INSPECTION REPORT:

PROPERTY ADDRESS: 757 Atkins Road
Fuquay Varina, NC 27526

DATE OF INSPECTION: November 17, 2022

NORTH CAROLINA SEPTIC INSPECTIONS

Pump Tank Control Panel Box:

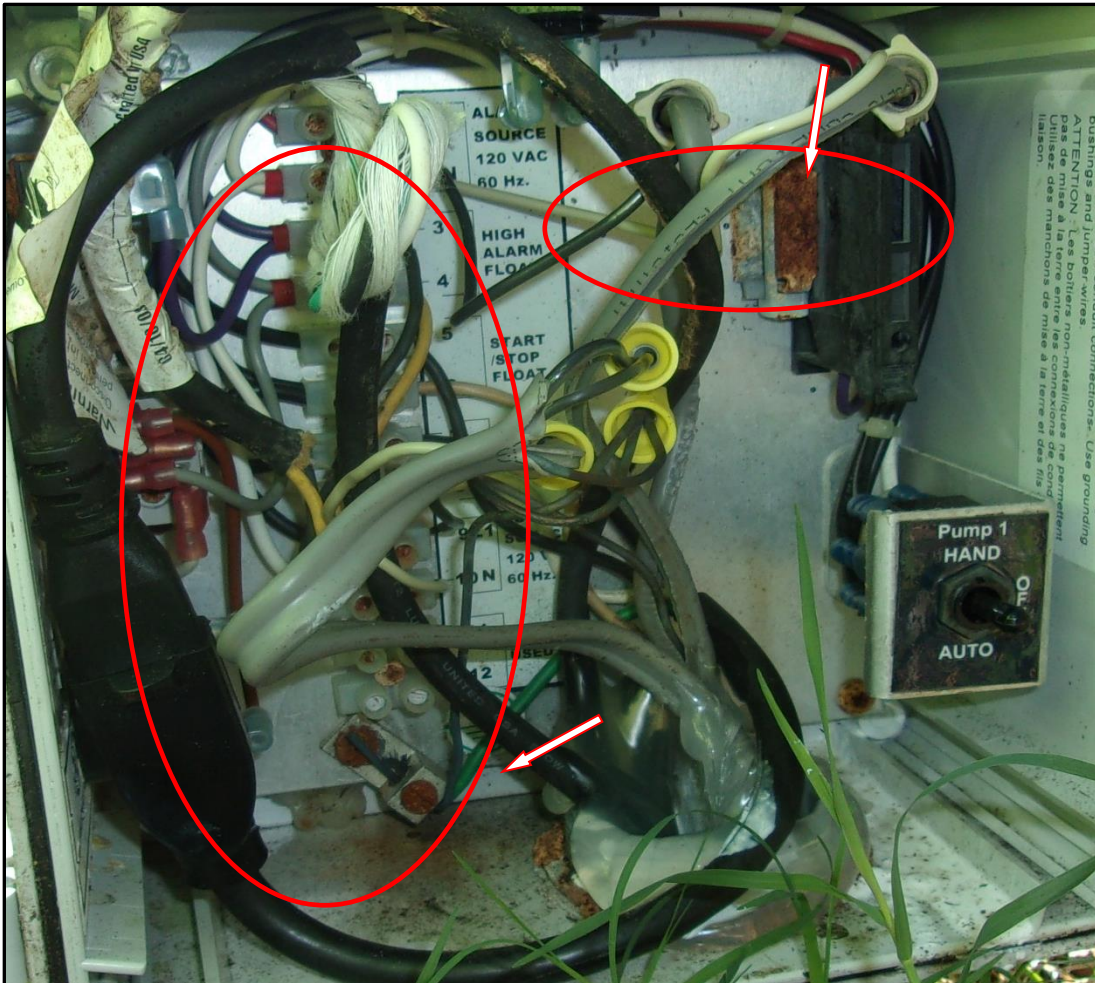
- 3). Electrical contacts in pump tank control panel box have rust and corrosion. To prevent possible electrical short, cleaning the terminals is recommended.

Existing Panel Box:

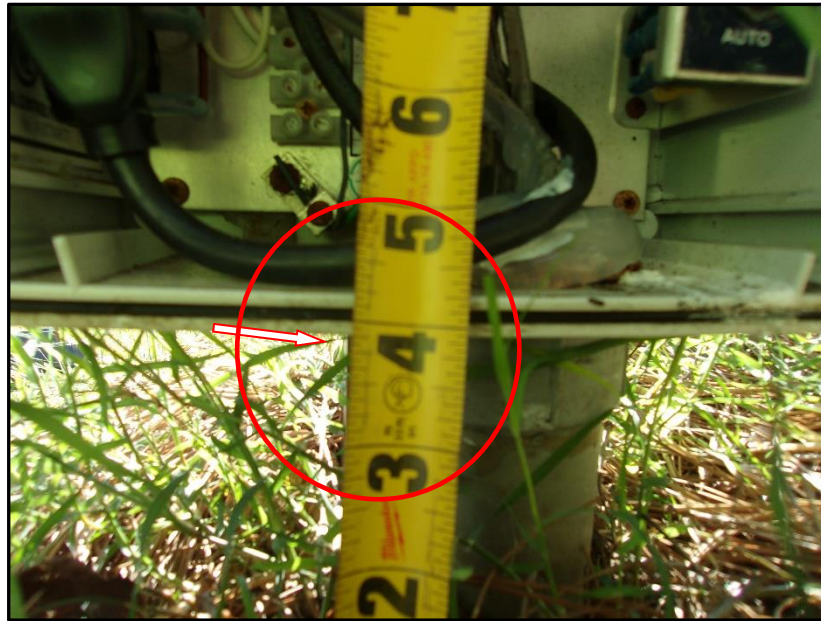
- 4). Pump tank Electrical Control Panel Box should be raised to a minimum of 12 inches above grade to prevent infiltration of surface water. In extreme rain events water possibly could reach levels of infiltration around base of box.

Nitrification Area (Diagram of lines may not be exact):

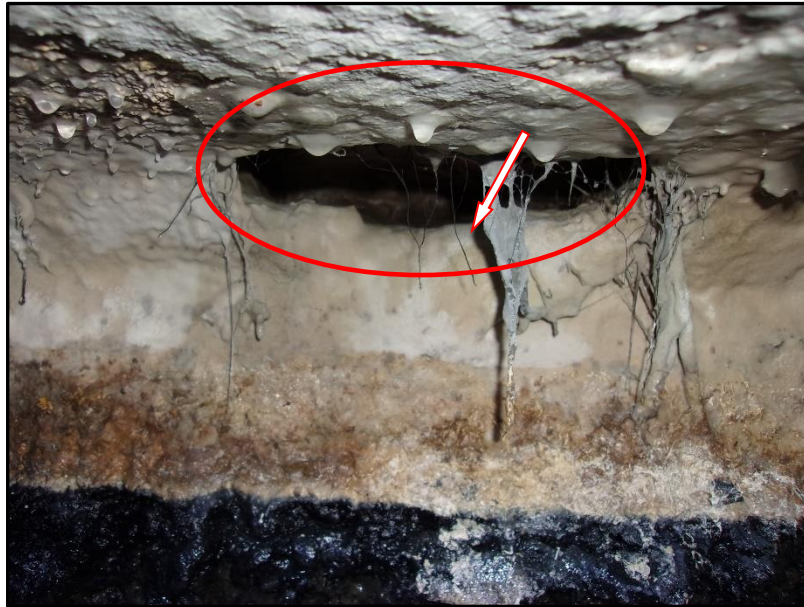
Nitrification field was located, and a visual inspection was performed. Nitrification field consists of two (2) lines, each approximately 150 feet in length. Probing confirmed the depth, however, the exact length or the configuration of nitrification lines was not confirmed. **Septic systems are subterranean, therefore, without exposing the actual nitrification lines and the soil absorption area beneath the lines it is impossible to make an accurate assessment of their overall condition.** Caution should be observed not to disturb the soil in and around the nitrification field and the adjoining designated repair area. It is always recommended to properly maintain the vegetation growth over nitrification areas. Planting appropriate vegetation over the leaching field is key to allowing a septic system to properly treat household wastewater and ensure the safety of your family and the environment. **FYI: All permanent structures should be a minimum of 5 feet from any or all portions of a septic system. In addition, it is important to avoid equipment or vehicular traffic over the nitrification area.**
